**CORRIDOR REVIEW COMMITTEE
 STAFF REPORT AND RECOMMENDATION**
 Prepared for January 8, 2026 Meeting

Application HP2025-0081

Address: 555 W. King Street

Project description: To construct a connected accessory structure to the west of the existing building and associated changes to the site and landscaping along the King Street Entry Corridor.

2 01 CANOPY PLAN
3/16" = 1'-0"

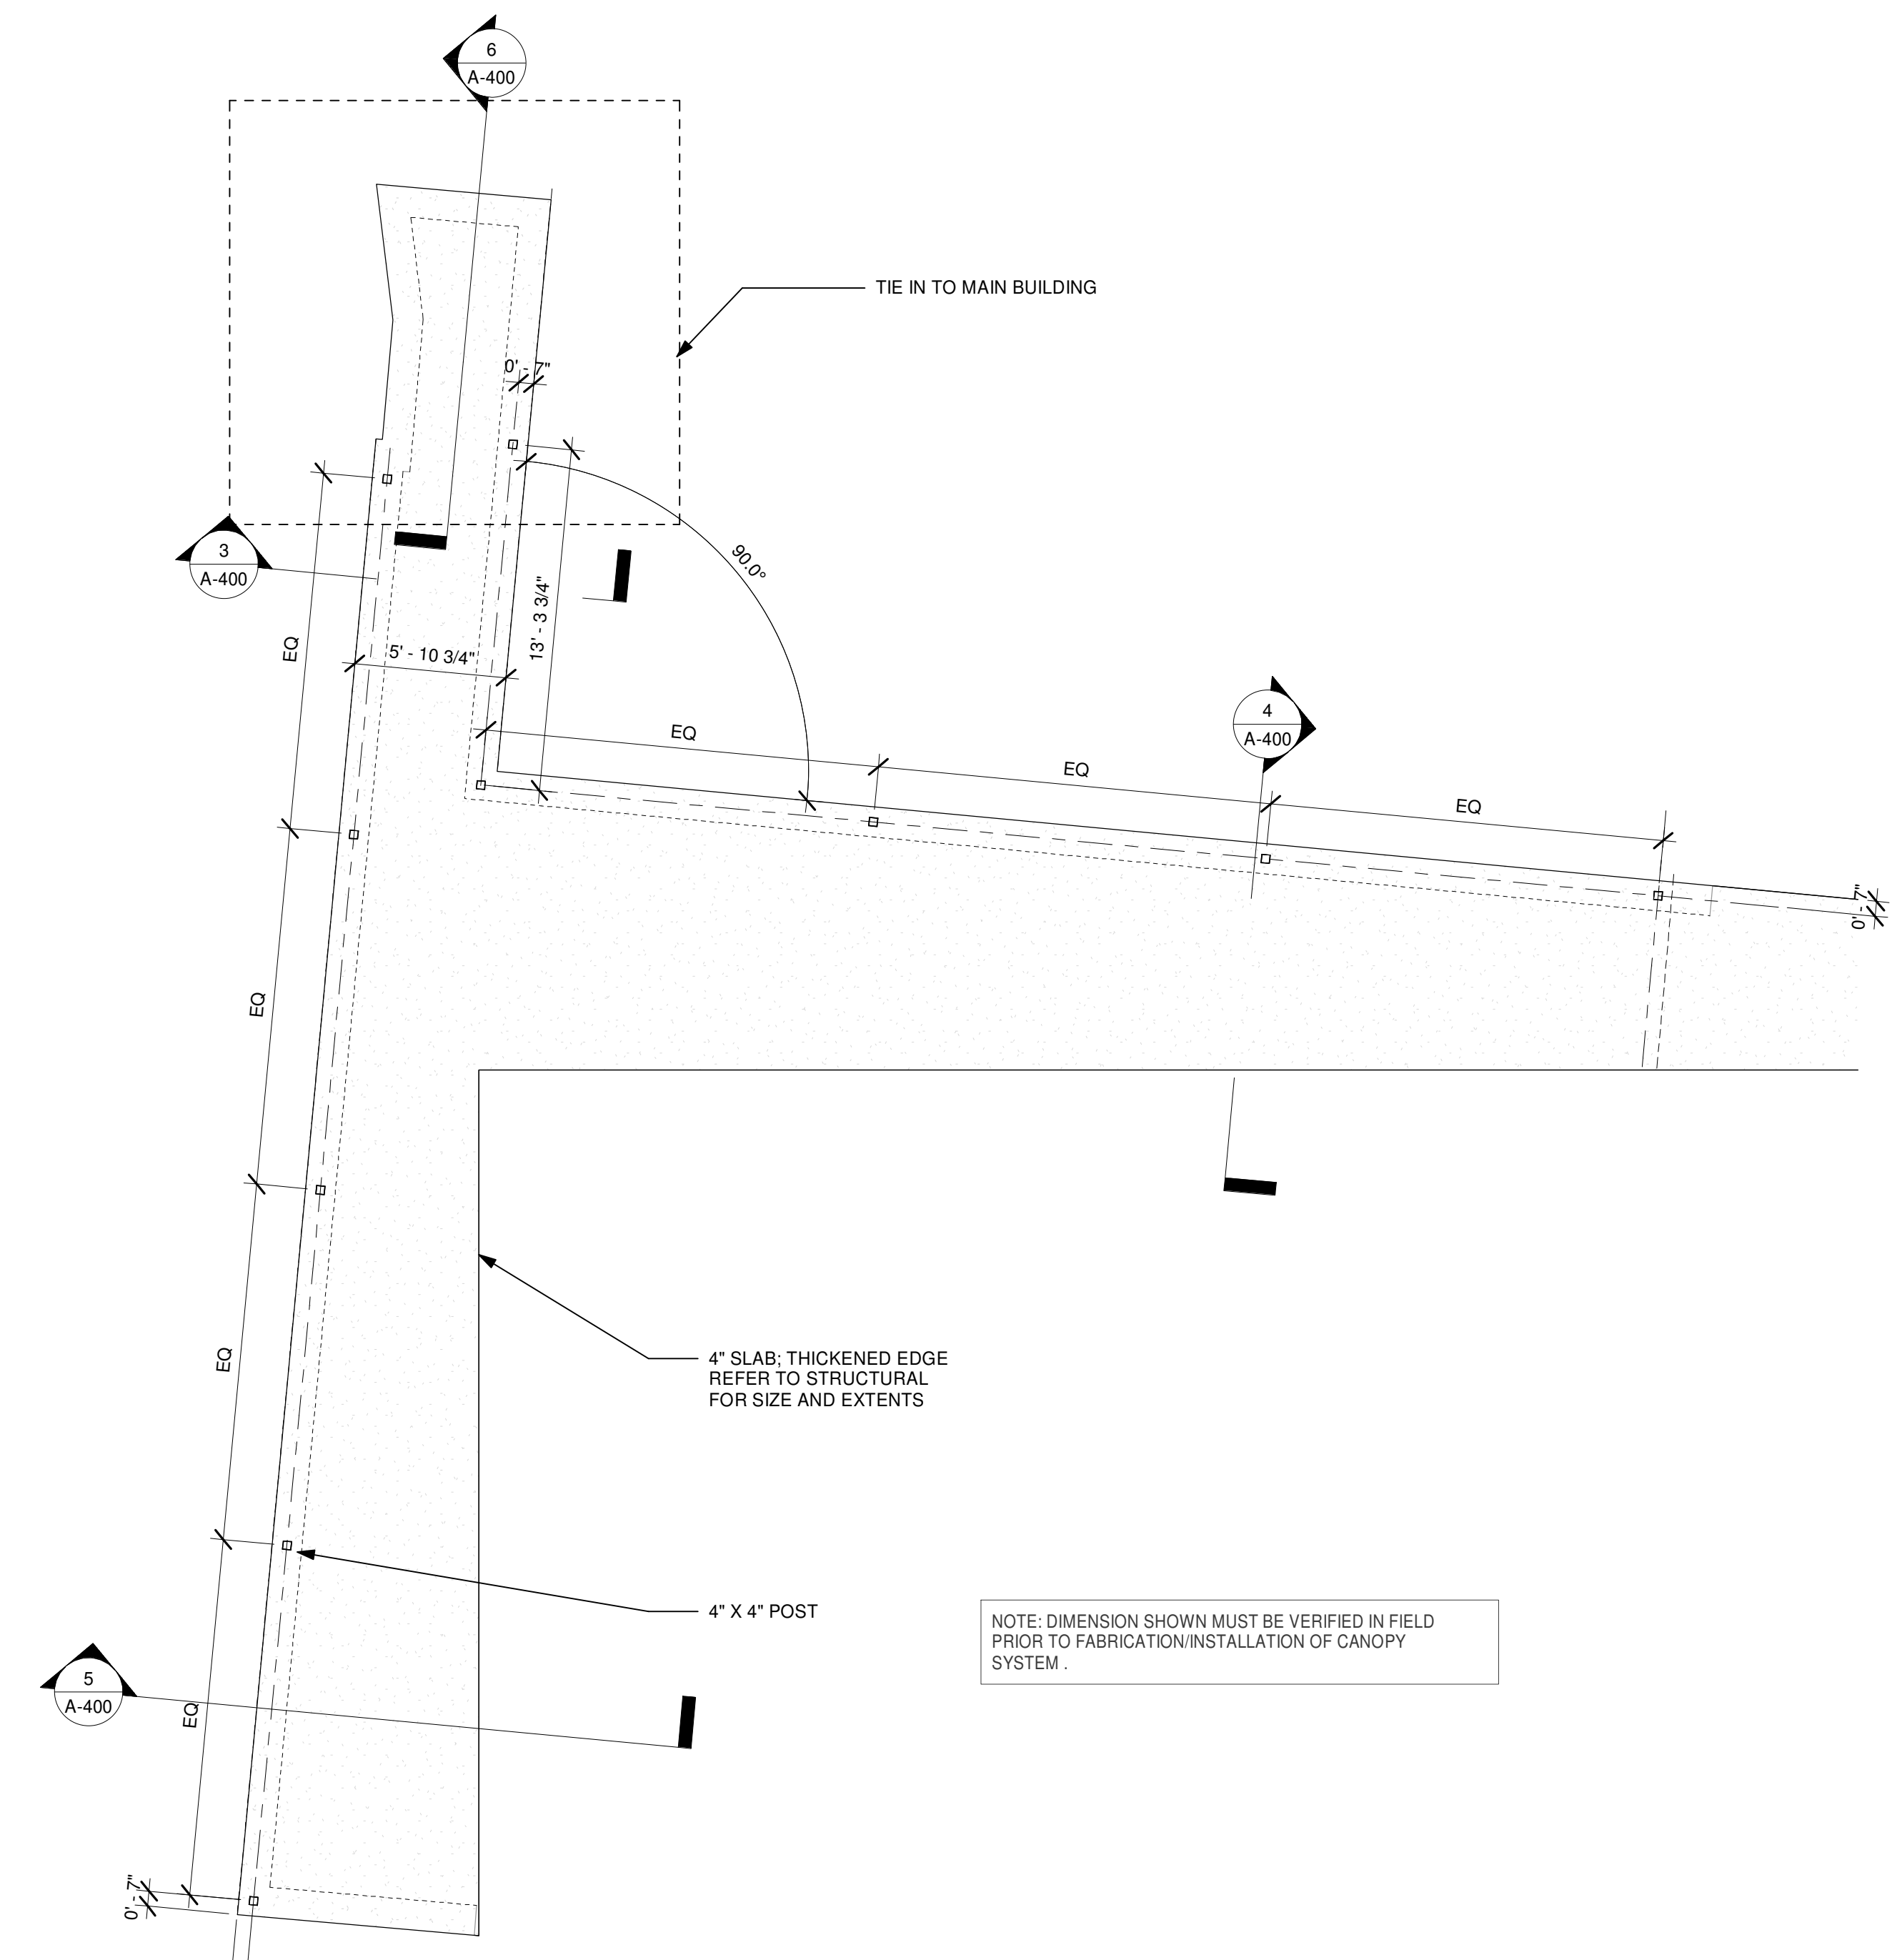
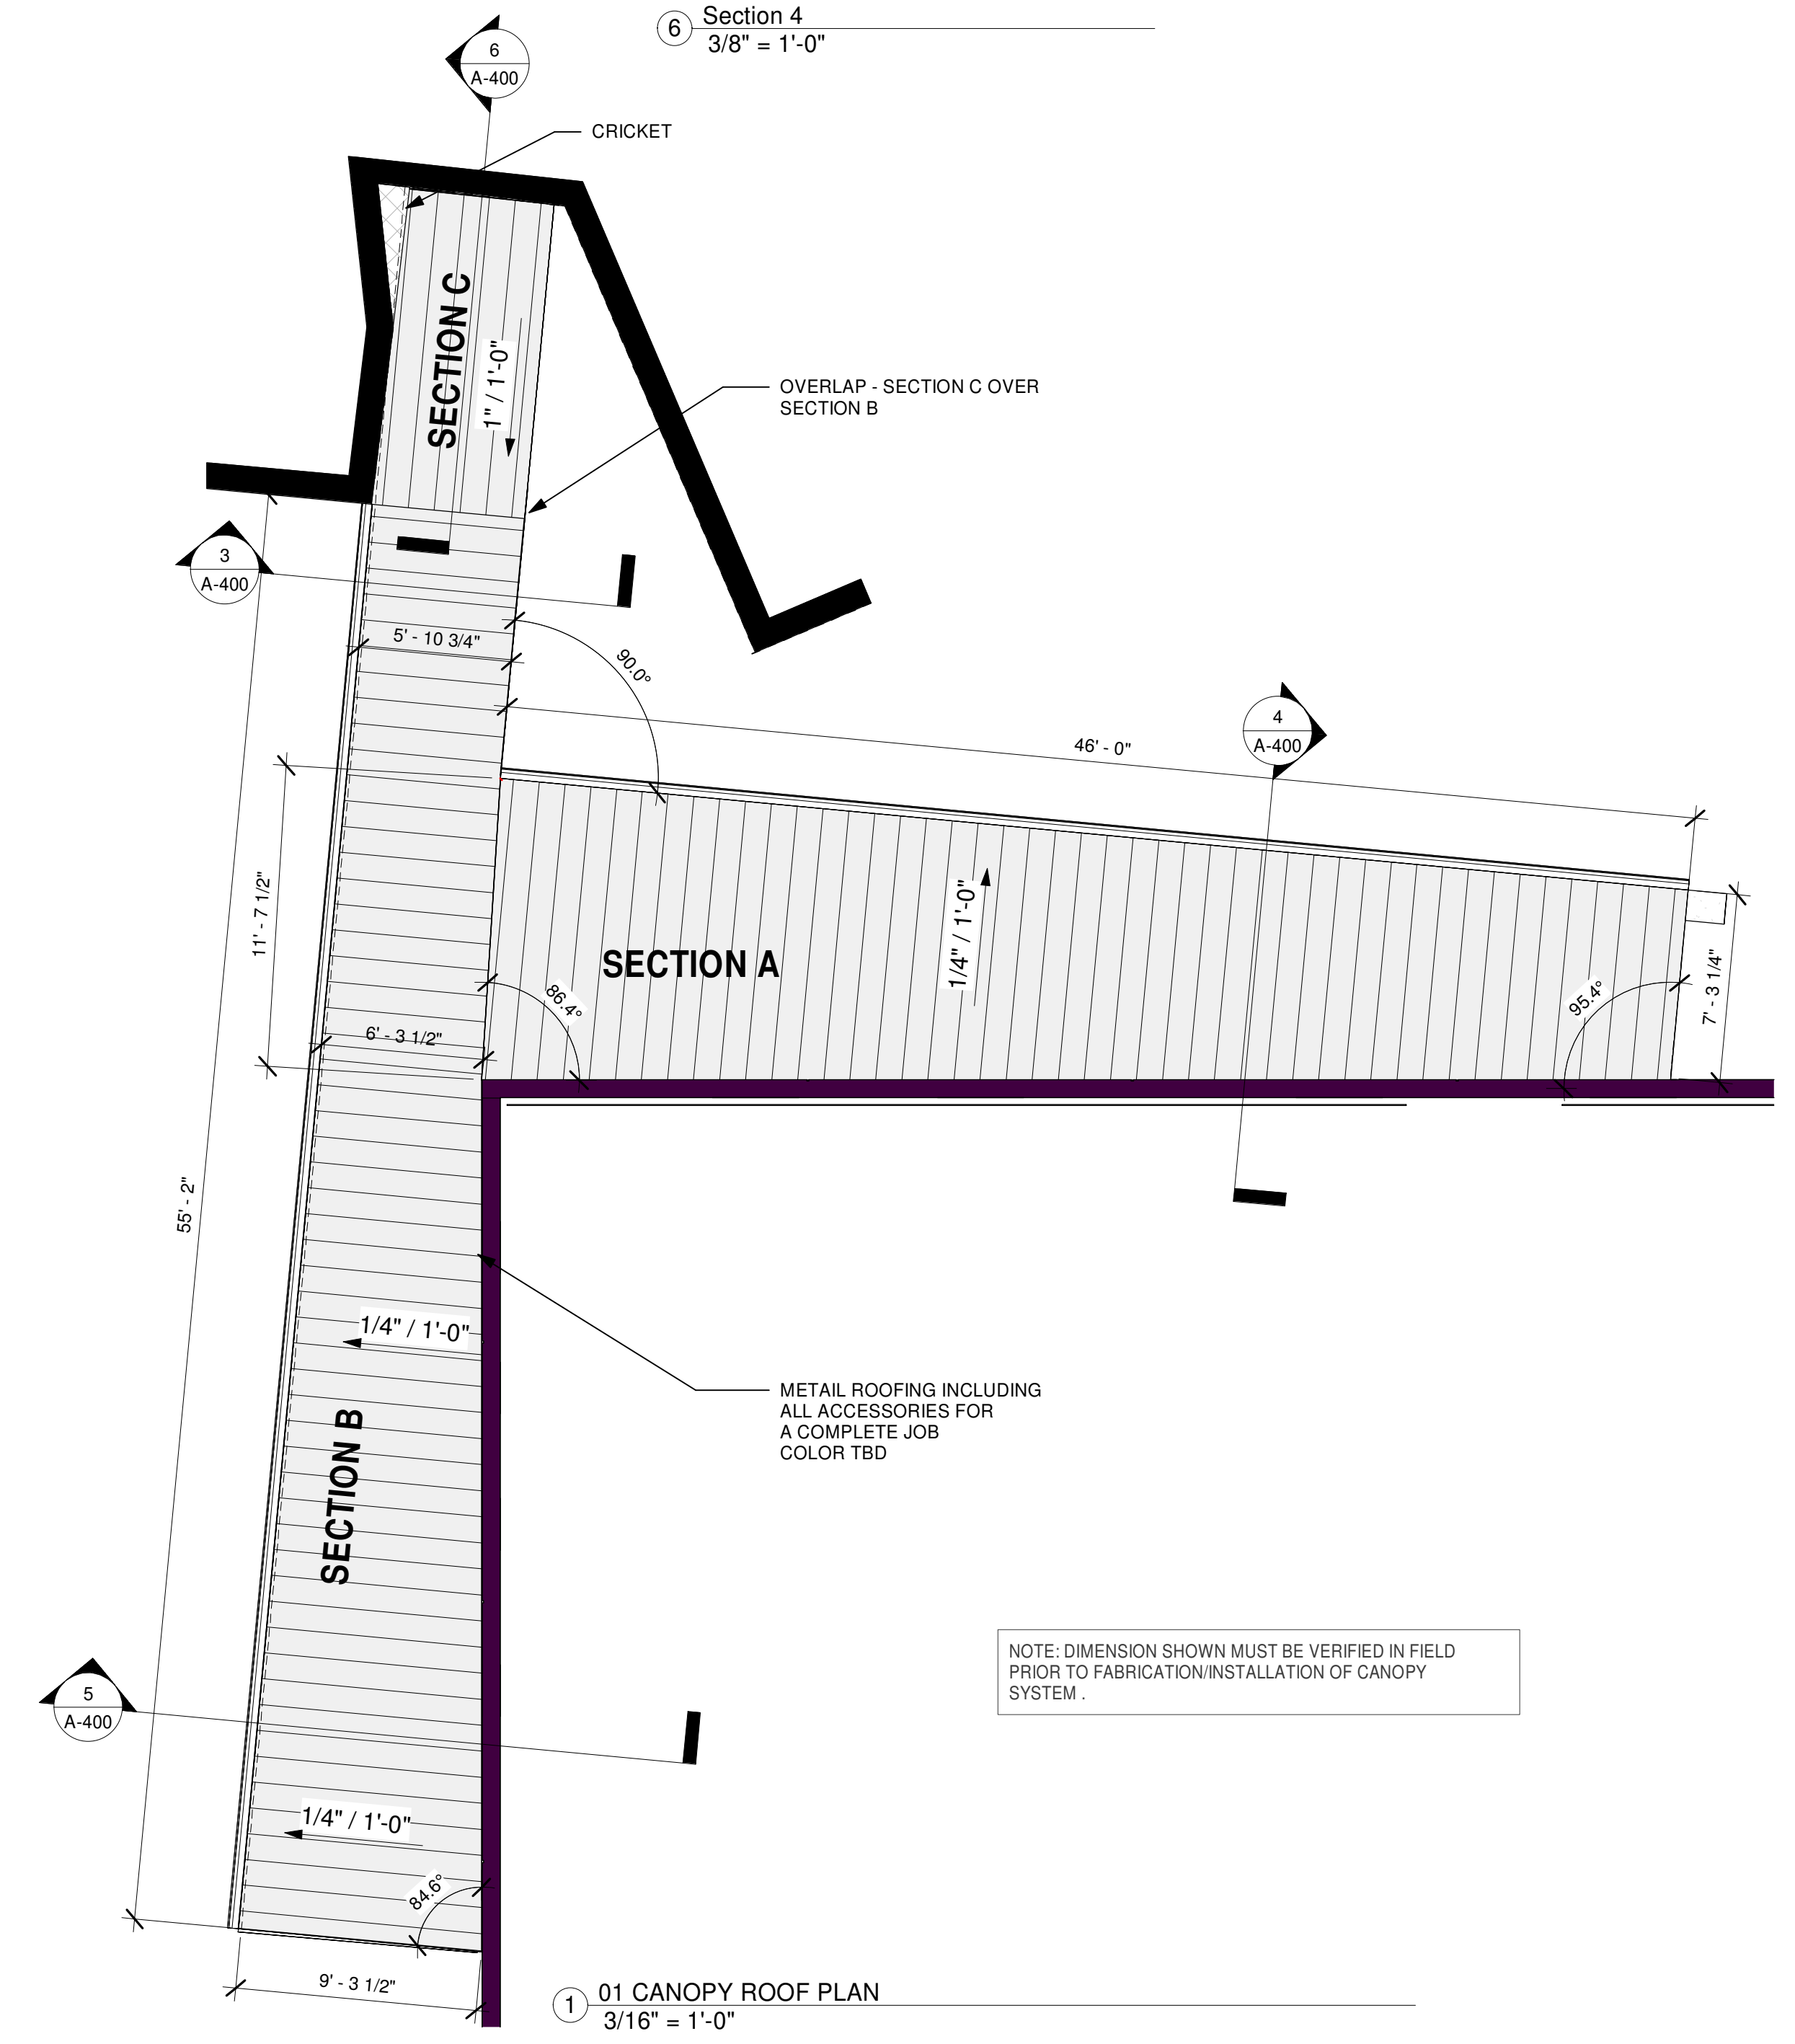
4. Section 4.4.6 of the Standards states that "awnings and canopies shall not obscure prominent architectural features," and, "shall be placed in a way to accentuate the architectural features of the building; therefore, shall not be installed to extend over multiple windows and doors." While the proposed canopy does cross the entire front elevation of the new structure, because it does not cross the primary façade of the building, it may be considered appropriate as proposed.
